LANCASTER REC CENTER CEILING/LIGHT REPLACEMENT

ARCHITECT'S PROJECT NO: 1805

ADDENDUM ISSUE DATE: August 3, 2018

**ADDENDUM # 1:**

SKA-1

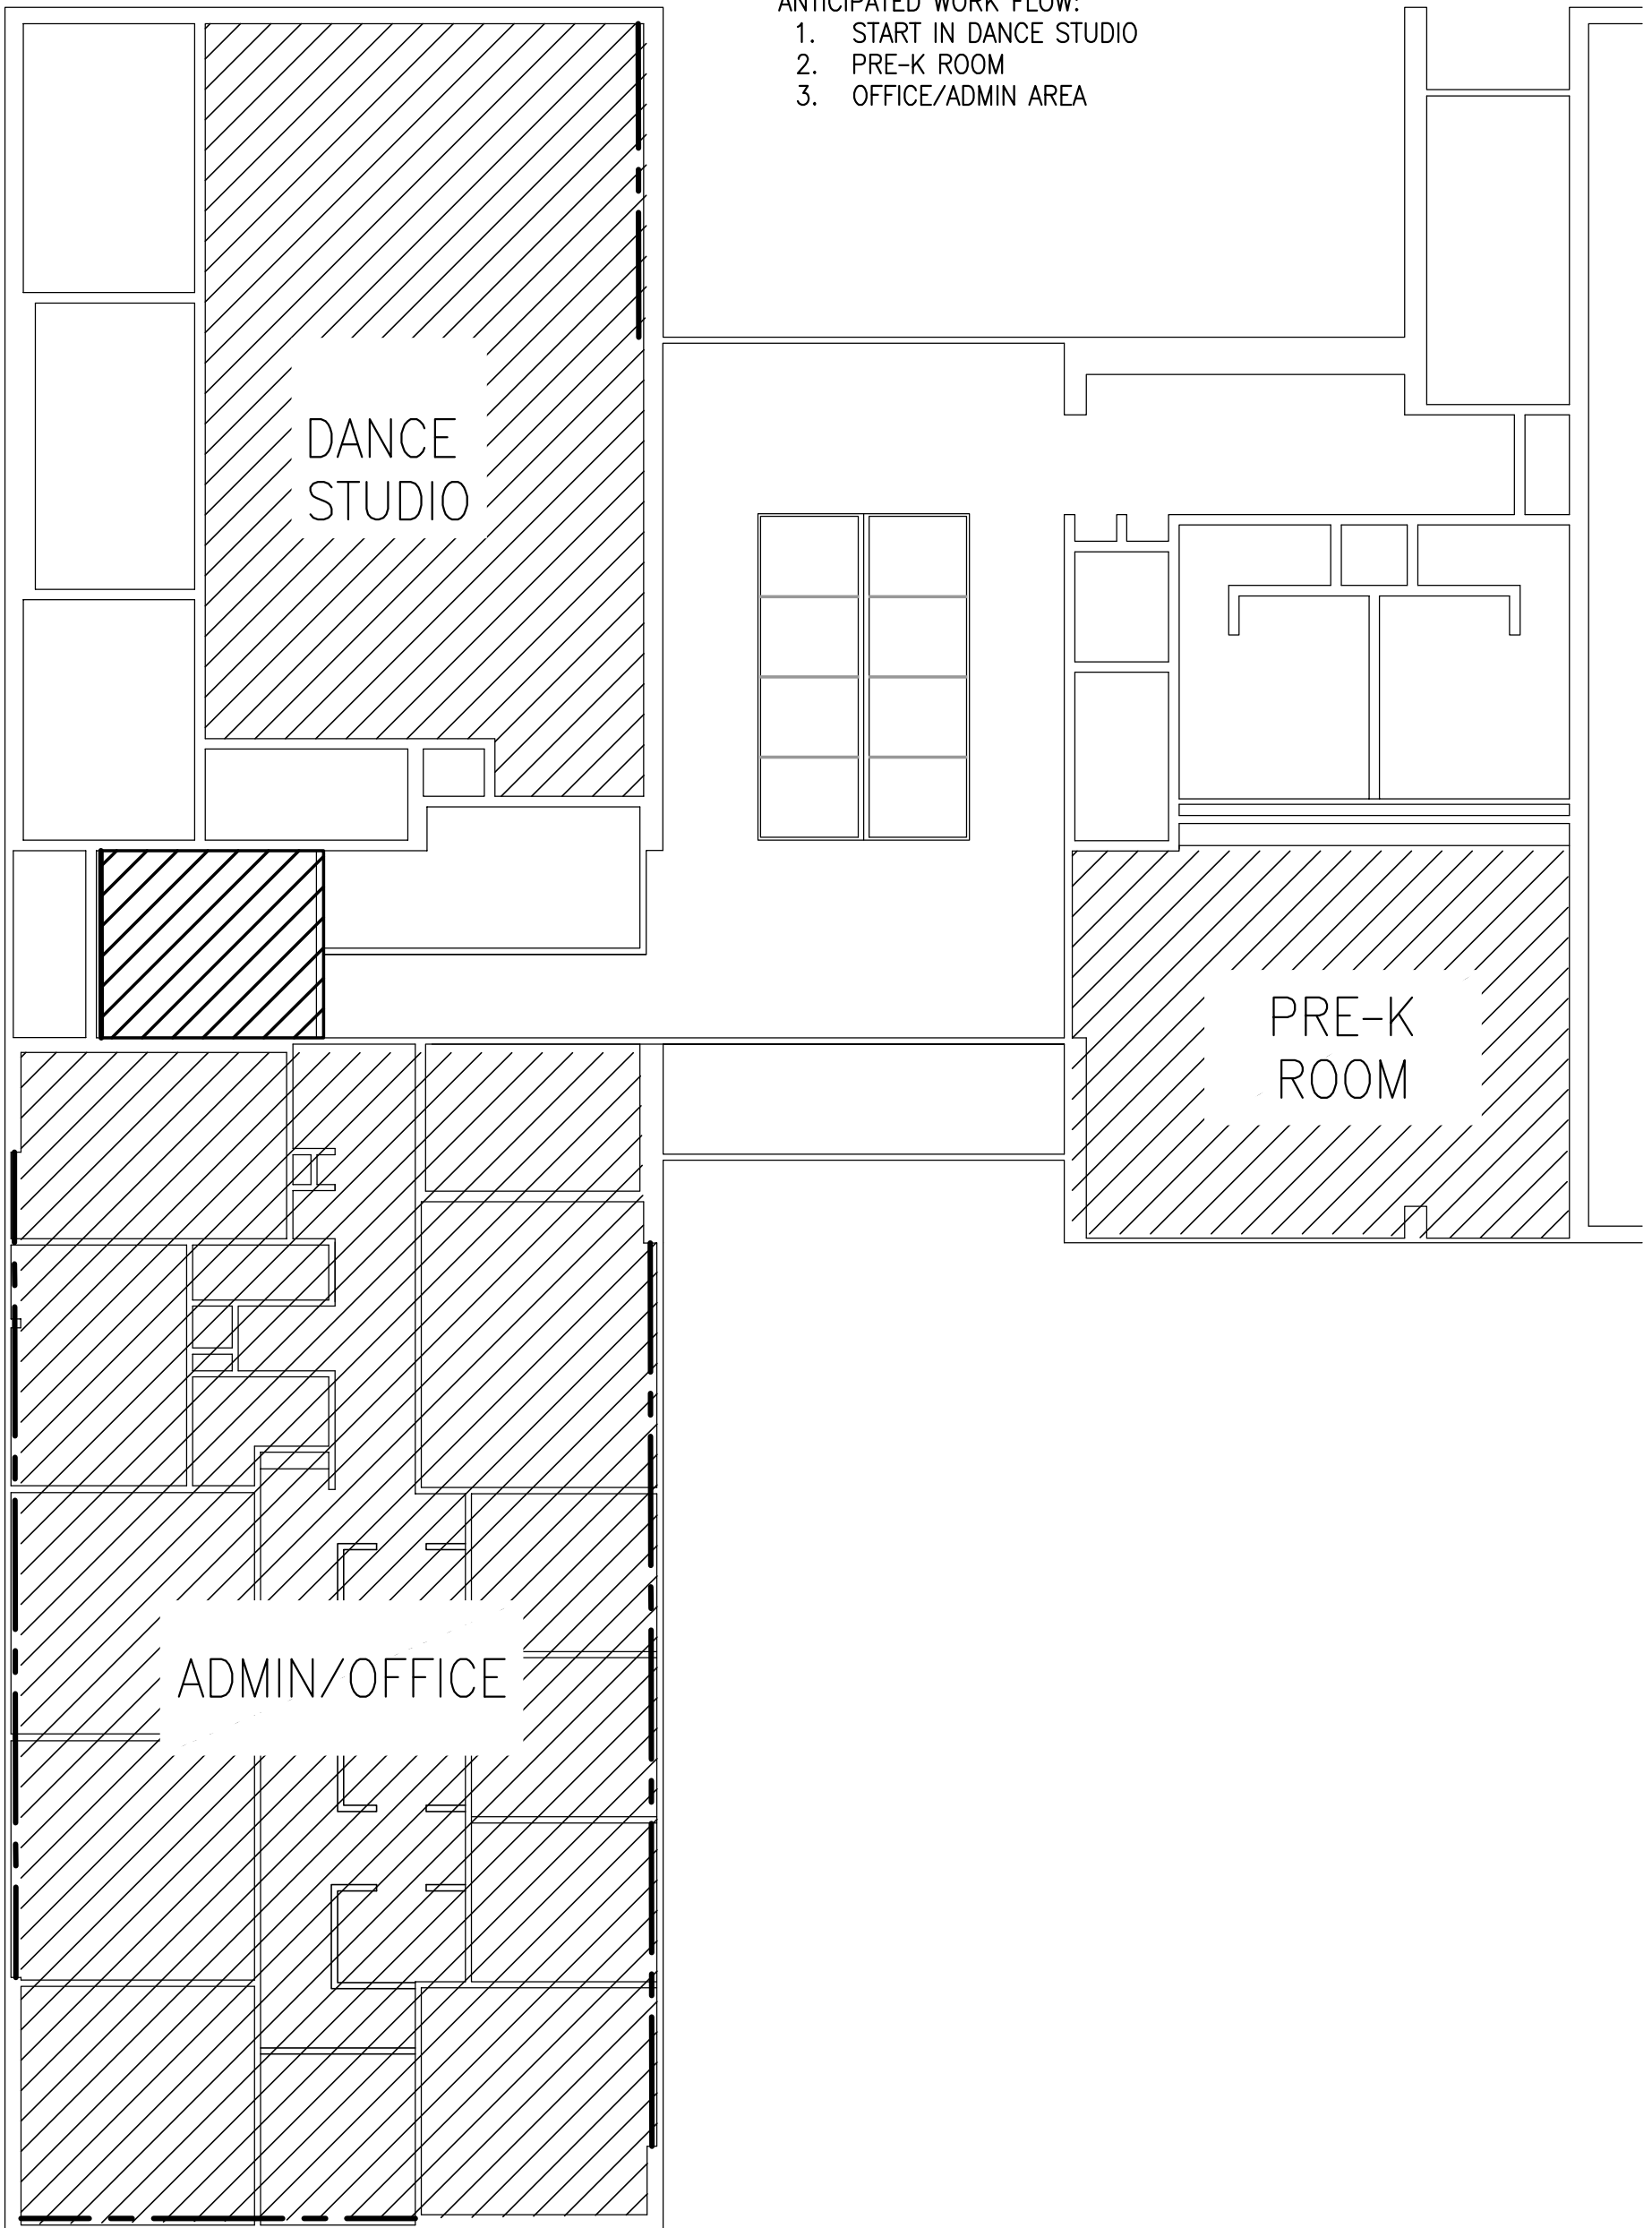
A	<b>Personal items will be removed from the office and some office furniture will be able to be moved from the spaces but not all. Cubical system will remain. A preliminary work flow plan is included in SKA-1. Further developed between the owners staff and the successful bidder will be required.</b>	HAA/LRC	8/3/18
5	Speedwell Construction	7/31/2018	Q	What are our hours of operations?		
			A	<b>The Rec Center is open for regular business hours of 9am-5pm, however the available work hours are 7:00 am to 5:00 pm or additional times with special arrangement and a minimum of 72 hour notice.</b>	LRC	8/3/18
7	Balton Construction	7/31/2018	Q	What is the deck height?		
			A	<b>Top of metal deck is indicated in the original drawings as 11'-10" AFF</b>	HAA	8/3/18

- ANTICIPATED WORK FLOW:
1. START IN DANCE STUDIO
  2. PRE-K ROOM
  3. OFFICE/ADMIN AREA
